<p>DECISION OF NORTH SYDNEY LOCAL PLANNING PANEL MEETING HELD ON 5 APRIL 2023</p>

DA No:	418/21
ADDRESS:	37 Bay View Street, Lavender Bay
PROPOSAL:	Erection of Dwelling house and associated works
REPORT BY NAME:	Jim Davies, Executive Planner
APPLICANT:	P Dugal C/- Architecture Saville Isaacs

ADDRESS/WARD: 37 Bay View Street, McMahons Point**APPLICATION No:** 418/21**PROPOSAL:** Erection of dwelling house and associated works**PLANS REF:**

OWNER: P Dugal**APPLICANT:** P Dugal, C/- Architecture Saville Isaacs**AUTHOR:** Jim Davies, Executive Planner**DATE OF REPORT:** 23 March 2023**DATE LODGED:** 3 December 2022**RECOMMENDATION:** Deferred Commencement

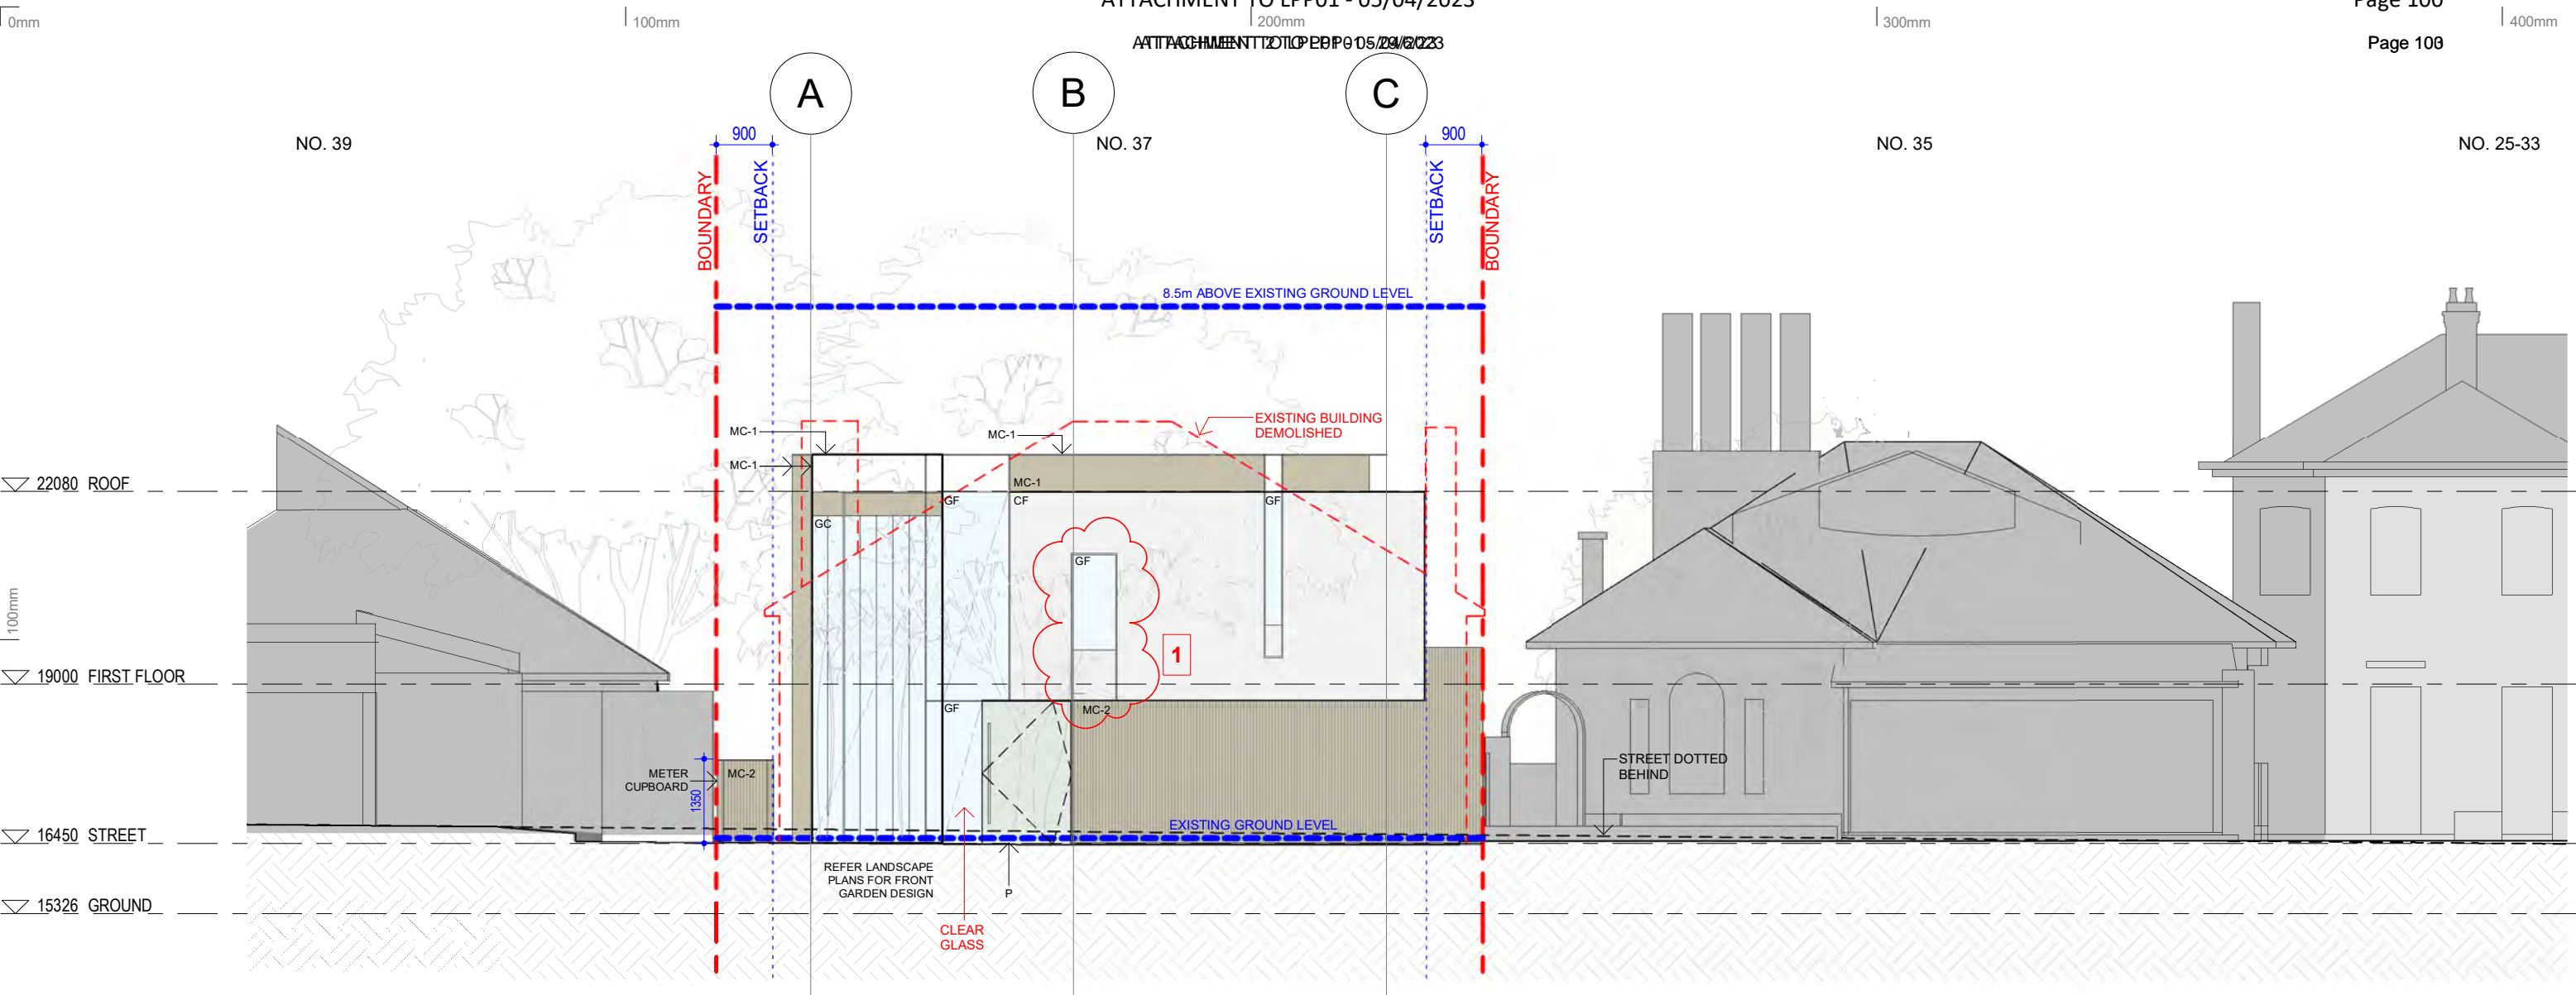
- 1** MINOR ADJUSTMENT TO STREET FACADE. WINDOW ADDED AS PER COUNCIL'S ADVICE
- 2** MINOR CHANGE TO FINISH AS PER COUNCIL'S ADVICE

Date	Rev	Issue	CLIENT	PROJECT	TITLE
2022.08.17	B	DA - Adjusted Graphics	T + P DUGAL	37 BAY VIEW STREET LAVENDER BAY, NSW	Elevation West (Street)
2022.11.30	C	DA - Additional Information			JOB No. 2033
2023.03.14	D	DA - Additional Information			DRAWING No. DA201
					REV. D

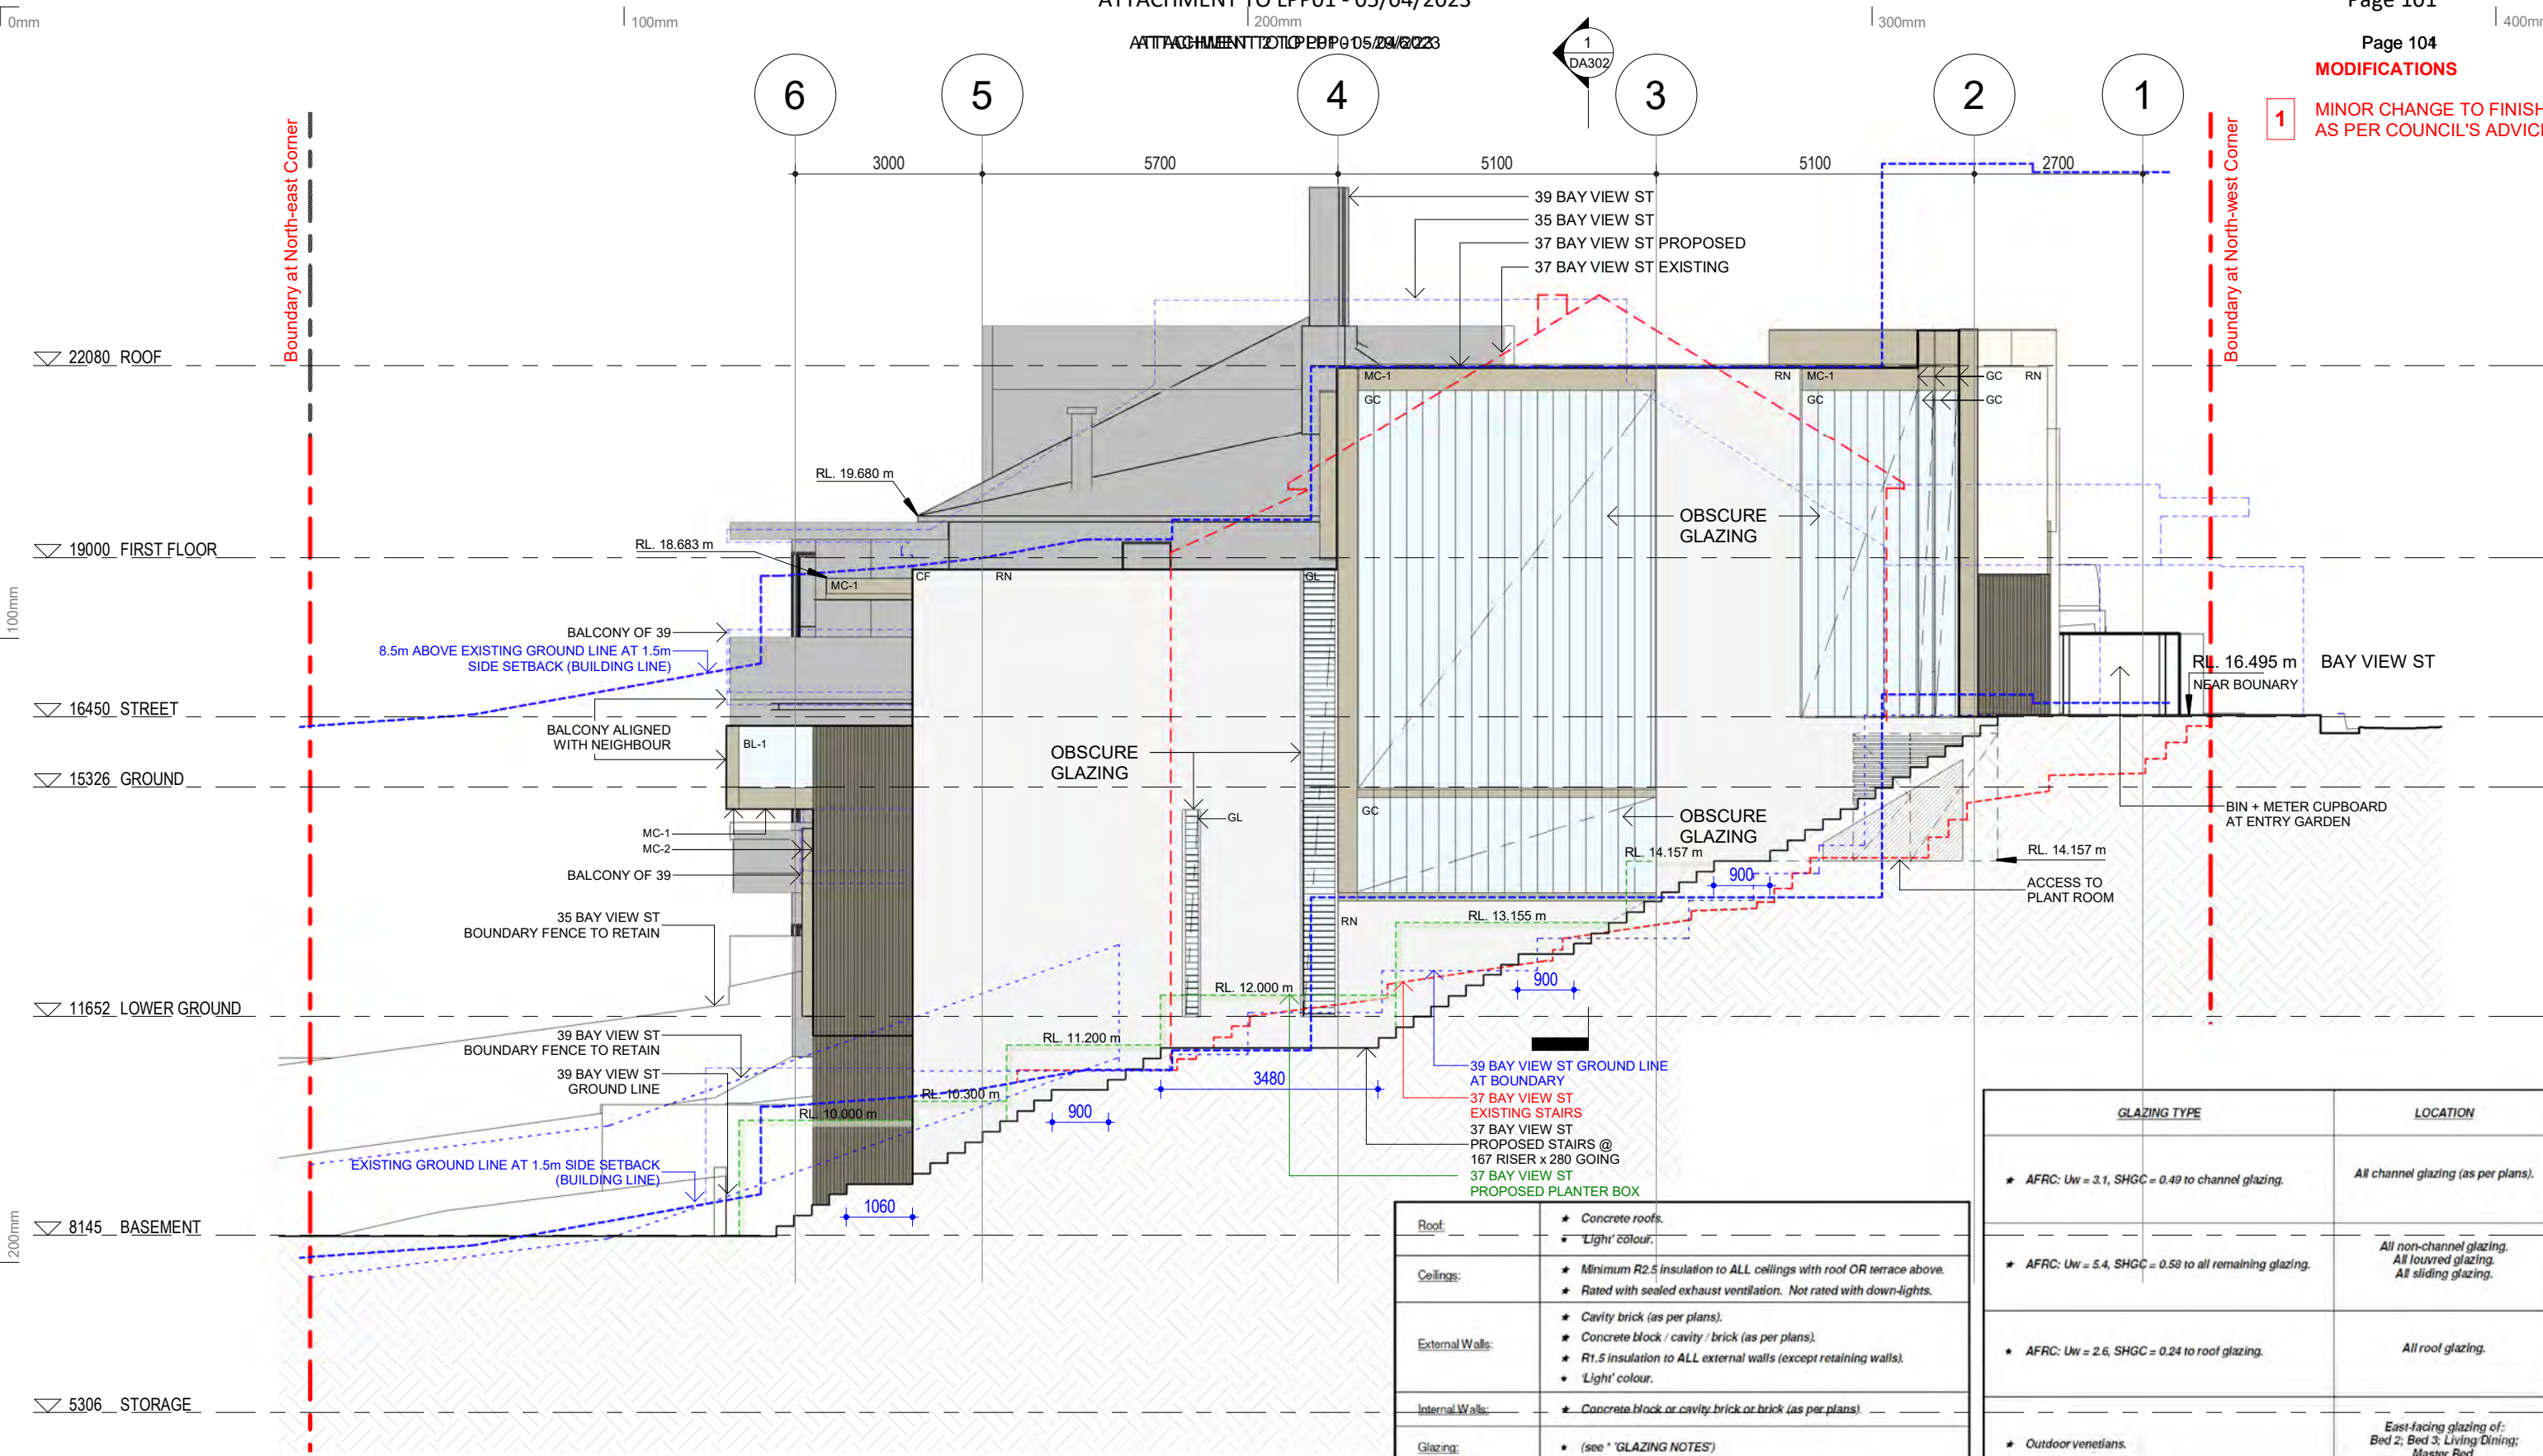
- 1** MINOR ADJUSTMENT TO STREET FACADE. WINDOW ADDED AS PER COUNCIL'S ADVICE
- 2** MINOR CHANGE TO FINISH AS PER COUNCIL'S ADVICE
